Office Action Summary	Application No. 10/580,168	Applicant(s) LINDNER ET AL.	
	Examiner STEPHANIE JENNINGS	Art Unit 4135

DETAILED ACTION

12. Limitations from claim 1, adjusting cylinder for long, rapid lifting movements in rolling stands, including vertical edging stands, wherein each cylinder has at least one piston (54, 56),

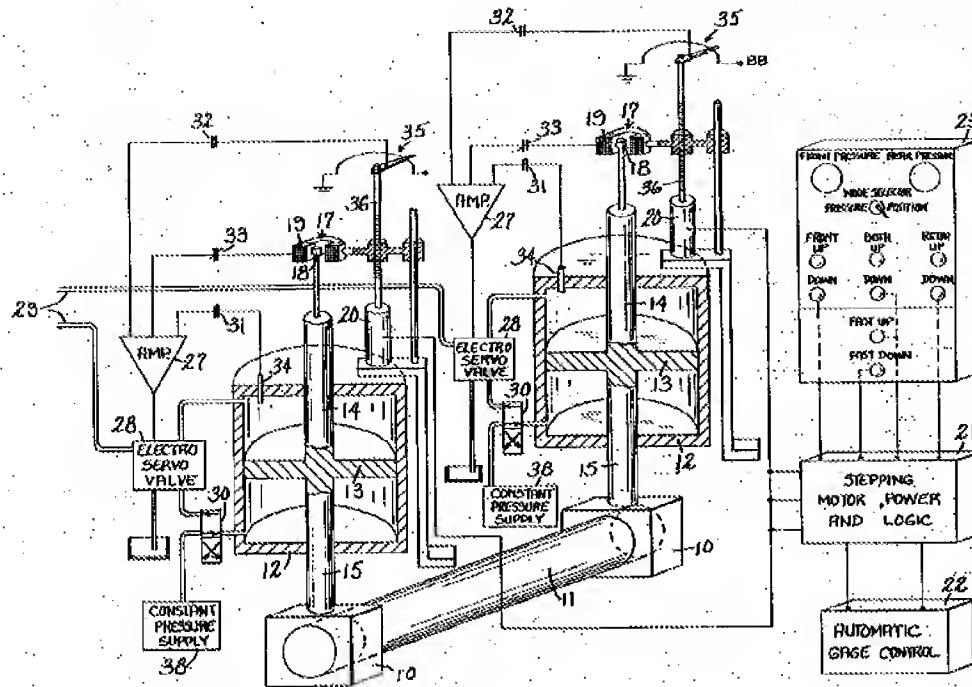
wherein each adjusting cylinder has a piston (54, 56) that is equipped with two oppositely directed piston rods (50, 52) which acts by means of the bearing chocks of at least one work roll or of an interposed roll to adjust a work roll on both sides and each piston is inserted in a recess in the cylinder base (42), such that said base and cover have coaxially arranged bores (44) through which the piston rods (50, 52) pass, wherein the surface (70) formed by the piston (54) and the piston rod (50) is smaller than the surface (72) formed by the piston (56) and the piston rod (52) (column 6, lines 12-40).

Fig 1

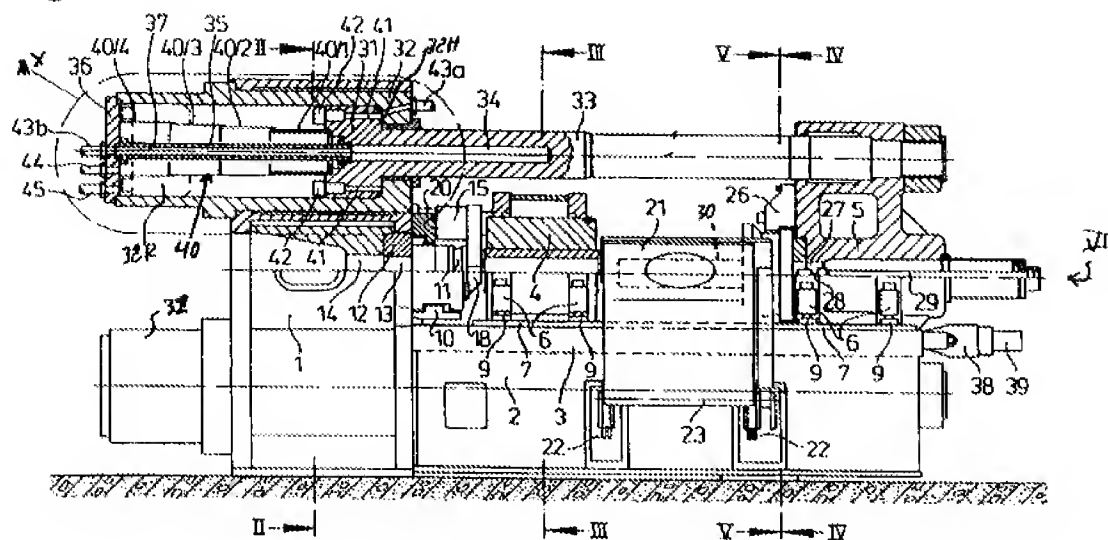
28. Limitations from claim 3, adjusting cylinder in accordance with claim 1, wherein seals that belong to the cylinder (32) are located in the cover (32R, H) and in the piston (31) (column 2, lines 38-45, column 4, lines 8-17 and 29-46).

29. It would have been obvious to one of ordinary skill in the art to combine Muschalik's invention with Herbst's and Gerber's invention because sealing the cylinders prevents the leakage of hydraulic fluid during operation.

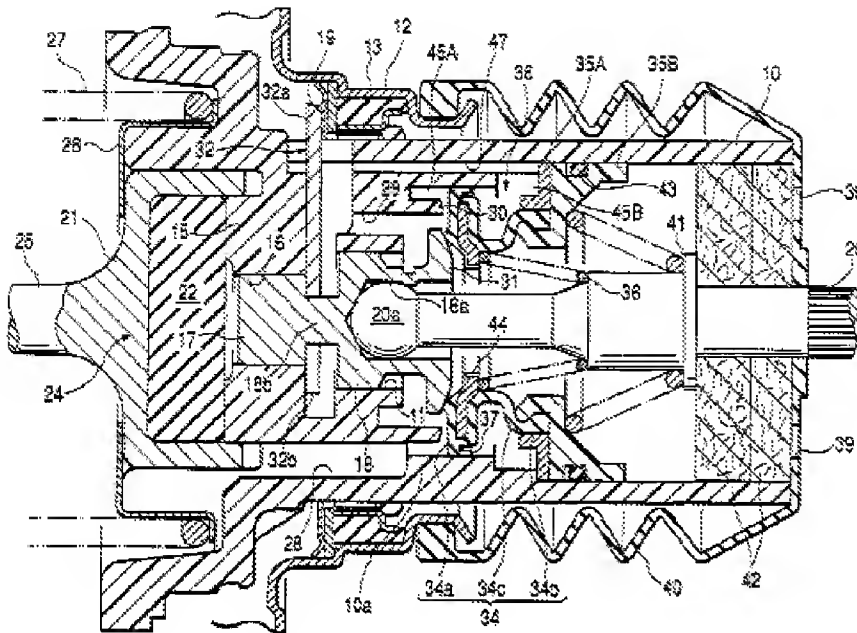
33. Limitations from claim 9, adjusting cylinder in accordance with claim 1, wherein the piston (translated abstract, paragraph 2, line 2) has an antitorsion device (translated abstract, paragraph 1, line 1)

34. It would have been obvious to one of ordinary skill in the art at the time of invention to combine Meise's invention with Gerber's and Herbst's inventions because an antitorsion device would prevent torsion and minimize damage to the apparatus or workpiece resulting from torsional stress.
